CITY OF WILLAMINA PLANNING COMMISSION
STAFF REPORT

FILE NUMBER(s): Subdivision #SUB 23-01 **“Ridgeview Heights, Phases 3-6”**
Variances #VAR 23-01, VAR 23-02, VAR 23-03, and VAR 23-04

OWNER: Willamina Ridgeview Heights, LLC. Attn. Tim Wenger

REQUEST(s): Applicant requests Planning Commission approval to subdivide 10.3 acres within Willamina city limits into 60 residential lots total: 18 lots will be attached townhouse lots, 42 lots will be detached single family lots (revised from original plan). The proposed subdivision phasing plan identifies phases 3–6. Phases I and II were approved in 2019, and have been constructed. As proposed, Phase III has 16 lots, Phase IV has 15 lots, Phase V has 14 lots, and Phase VI has 15 lots.

B. PROPOSED SUBDIVISION PLAN (See full size plan in Exhibit B)

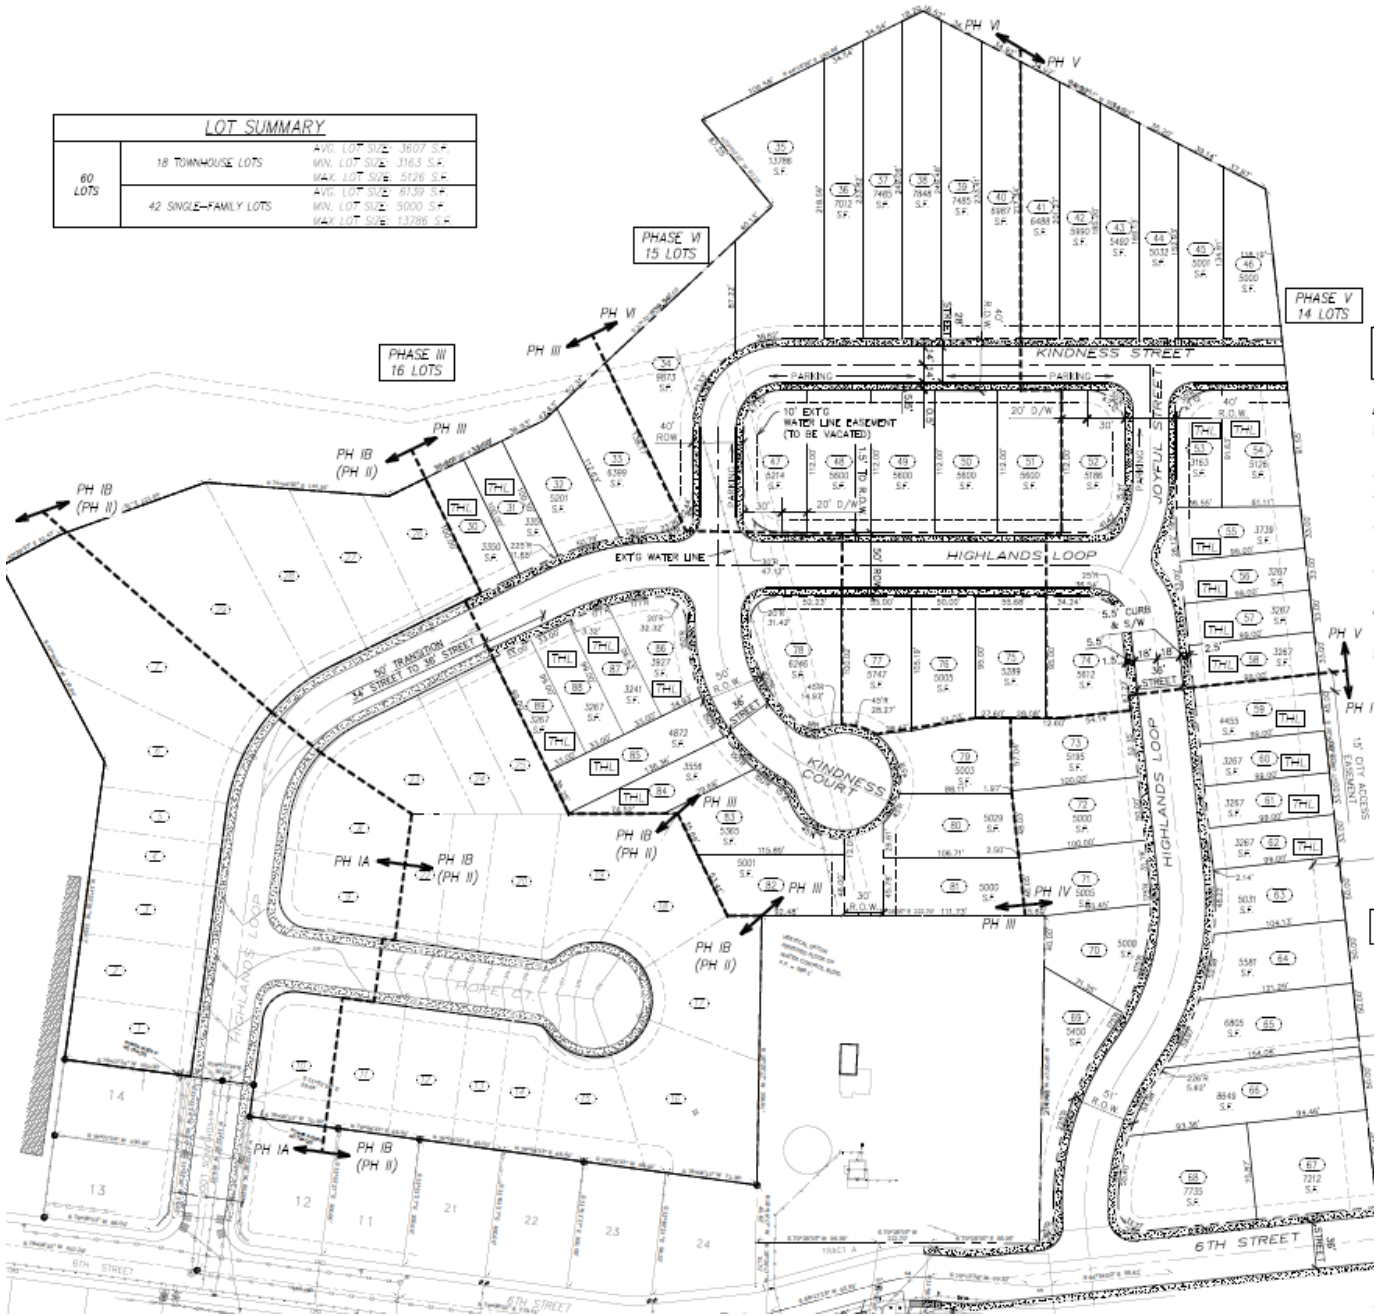
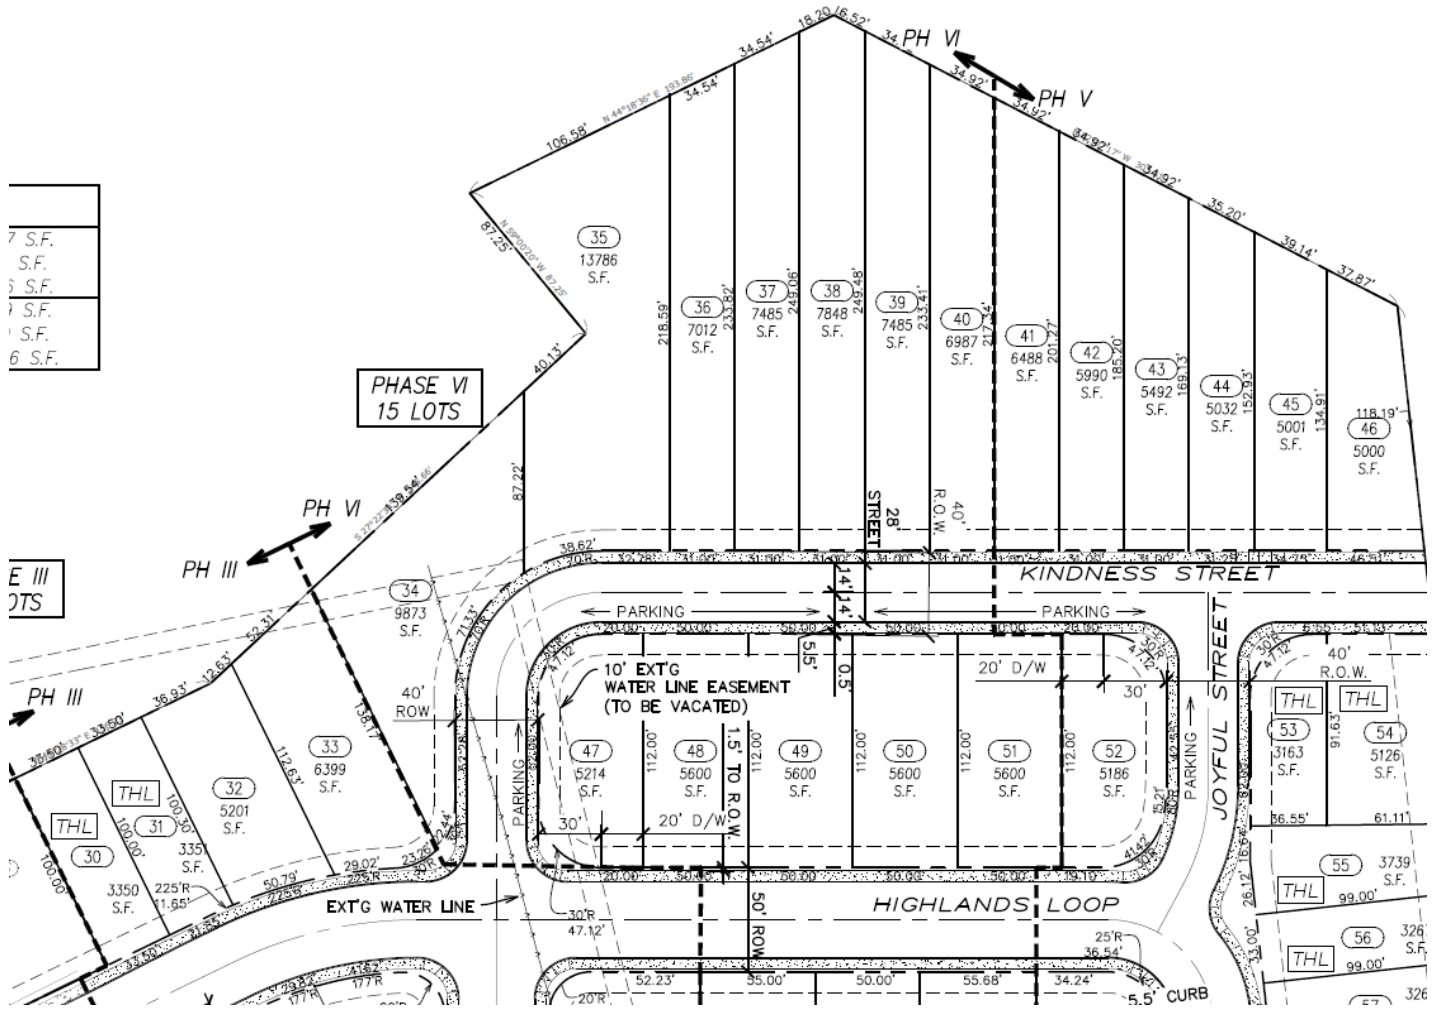
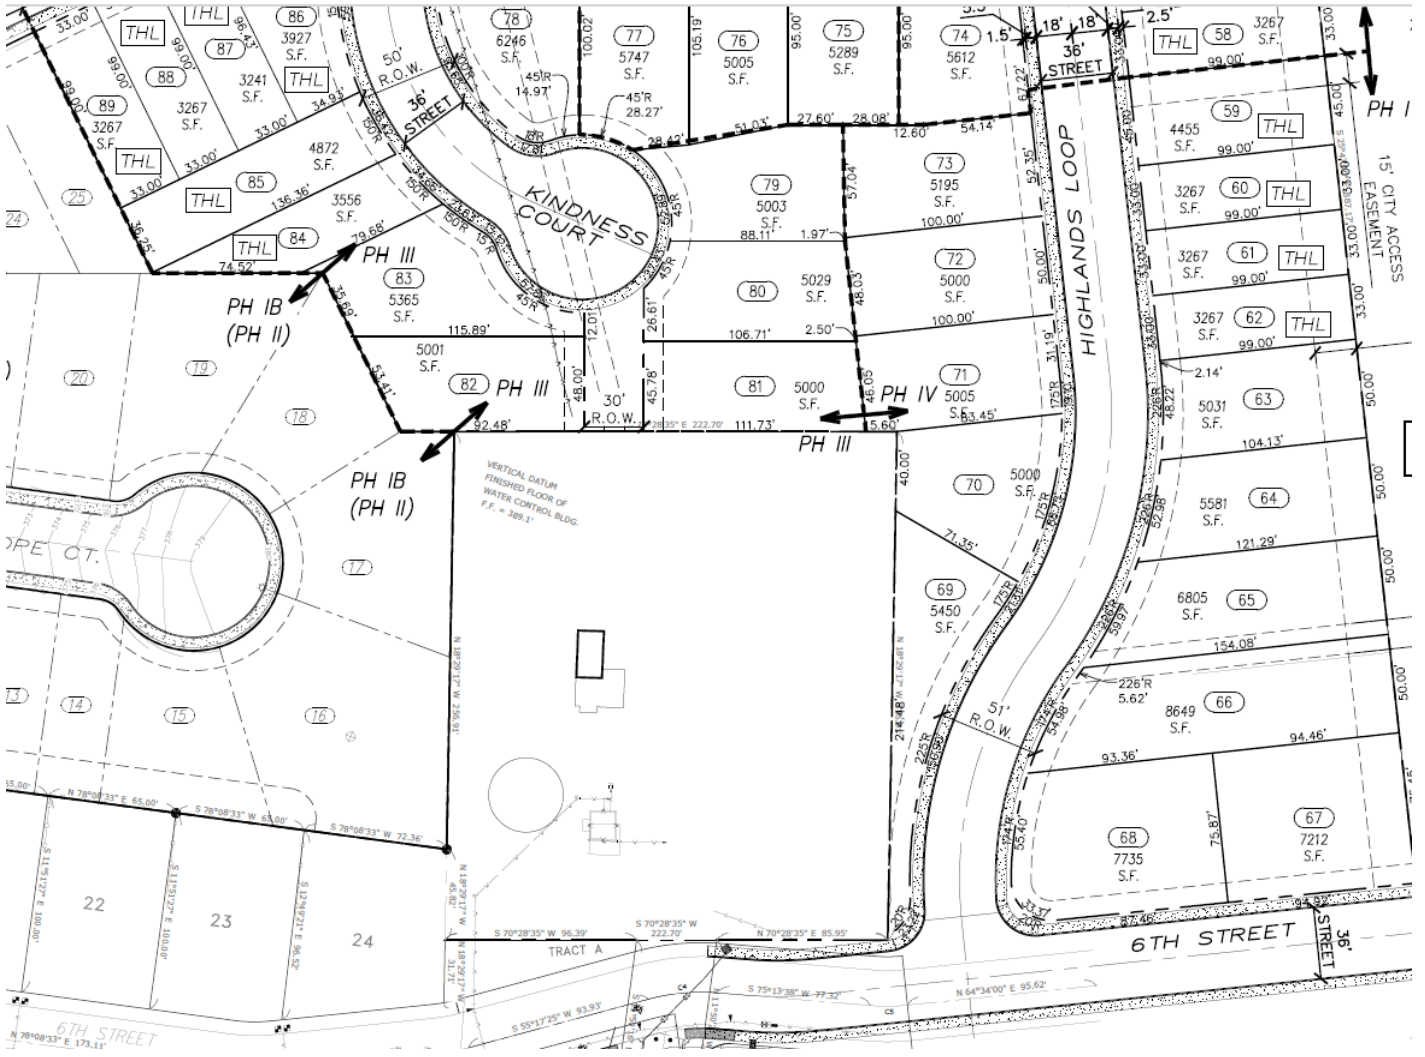
Aside from the proposed townhouse lots, there is a row of lots which do not meet the minimum 50-foot frontage standard. Lots #36-46 do not meet the frontage width standard. The applicant has applied for a variance to the lot width-to-depth ratio for these lots, but no variance is submitted for the lot width standard. While the lot depth-to-width ratio is supportable due to steep slopes, the developer has full control over the frontage width. Staff has included a condition of approval that these specific lots will either be brought into compliance by making the non-conforming lots attached units (townhouses) or reducing the number of lots on this block to meet the 50-foot frontage width standard.

Lots 81 and 82 also do not meet the frontage width standard of 50 feet. They do not take access from the actual cul-de-sac. A corresponding condition requires those to comply prior to final plat approval. This standard can be met.

8. LOT WIDTH. Consistent with WDC 2.102.04 and 2.208.03, single-family attached lots shall have a minimum lot width of 20 feet and single-family detached lots shall have a minimum lot width of 50 feet, or 40 feet on a cul-de-sac. Lot width to depth ratio shall be met, unless otherwise approved through a variance application addressed herein. Prior to final plat approval, Lots 36 – 46 and Lots 81 - 82 shall be revised to meet this standard, either through the designation of THL, or the elimination of one or more lots to meet this standard.

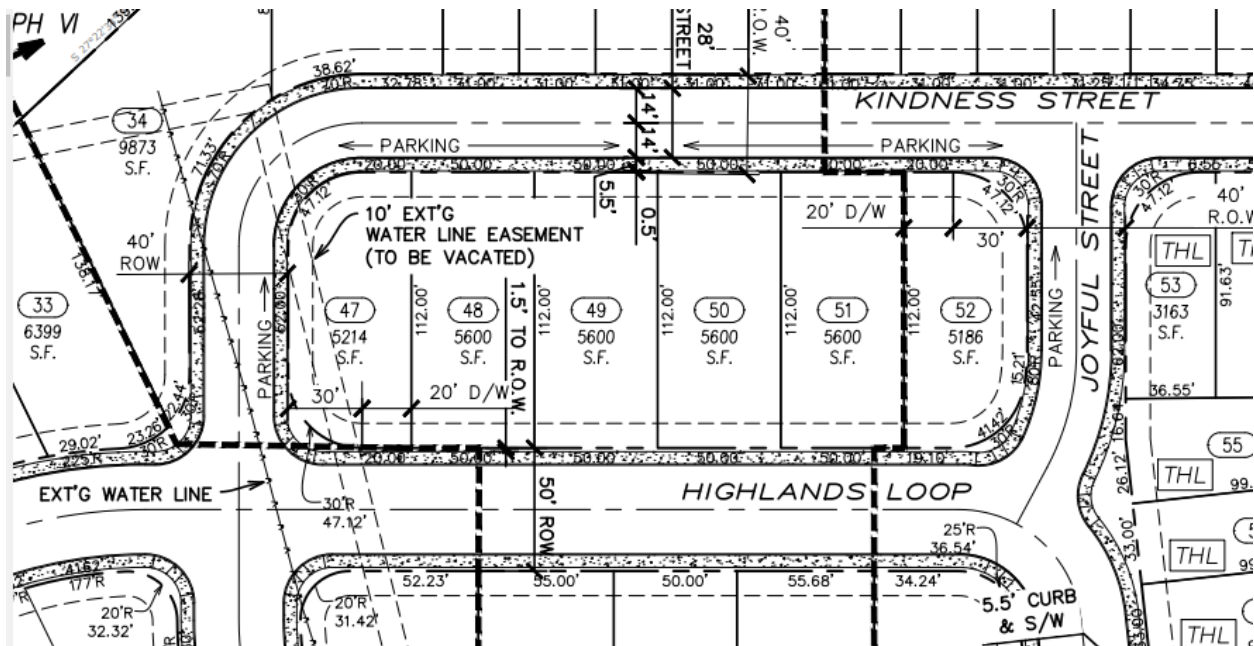
Because of the location of the City's property abutting the subject property, complete street connectivity was not feasible. A cul-de-sac is proposed.

A. VARIANCE #VAR 23-01: Variance to lot depth-to-width ratio for lots 33, 35-46, 65, 66, 84, 85.

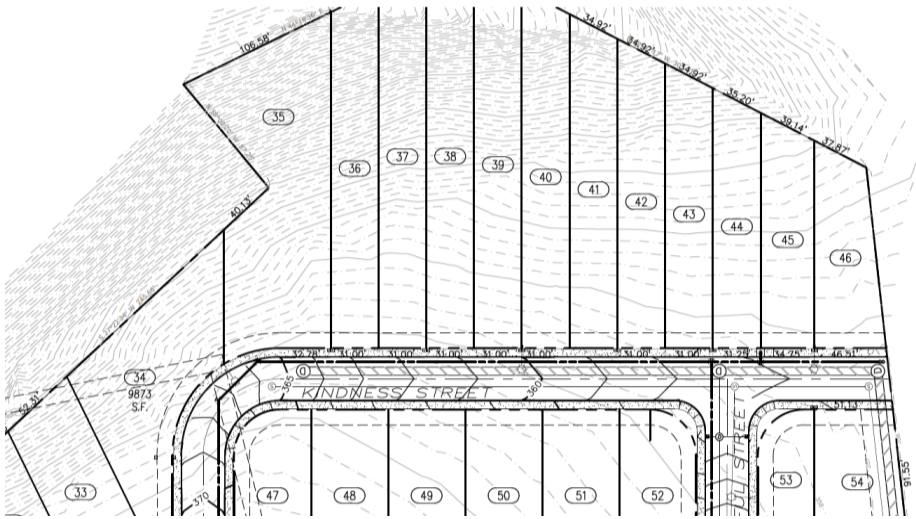
The applicant states “The variance requested is due to the existing property configuration and topographic constraints of the site. The northerly portion of the property is very steep eliminating the possibility of a street which would negate the need for a variance for lots 35 through 46. Because of the existing topography, it is necessary to have long, skinny lots (Lots 35-46). The configuration of Lots 33, 65, 66, 84 and 85 are restricted due to the existing property boundaries and the required street layout required to connect to the existing street network and provide ADA accessible routes. The lot width to depth ratio for these lots is not significantly over the Standard.”

Staff concurs with the applicant’s response. The variance is necessitated in the interest of utilizing the land most efficiently, while navigating steep slopes and street alignment challenges. The unique steep slopes render the northern portion of the lots unbuildable. For this reason, the applicant is looking for relief from the standard in order to build smaller dwellings on narrow lots abutting Kindness Street. These narrow lots are not proposed to be townhouse lots, rather, the developer envisions smaller cottages. The overall lot size for each of these lots exceeds the minimum lot size of the R2 zone. Related to the narrow lot size, staff has included a recommended condition of approval for the applicant to comply with the minimum lot frontage by either developing some of the lots as townhouses and/or reducing the number of lots on the block to meet that standard. Even when one or both of those actions are taken, this variance request will still be necessary, and would still be supported due to the constraints of the slopes. Example of the topography shown below in a screenshot from the applicant’s plan set:

FINDINGS: As noted above, staff does expect a minor revision to the lots along the northern side of Kindness Street to comply with minimum frontage width. That/those revision(s) may result in a smaller variance to alleviate the hardship.

B. VARIANCE #VAR 23-02: Variance to through lot standard for lots 47 – 52.

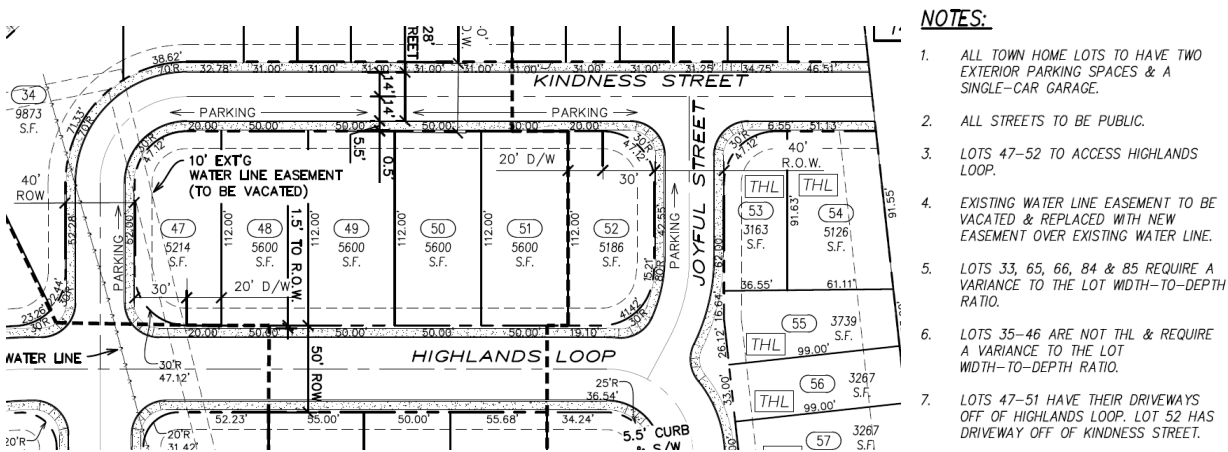
FINDINGS: WDC 2.208.03 E. ‘Through Lots: Through lots shall be avoided except where essential to provide separation of residential development from major traffic arteries, adjacent non-residential activities, or to overcome specific disadvantages of topography and orientation. Screening or buffering, pursuant to the provision of Section 2.207, may be required by the City during the review of the land division request.’

Staff concurs with the applicant’s response. The variance is necessitated in the interest of utilizing the land most efficiently, while navigating steep slopes and street alignment challenges.
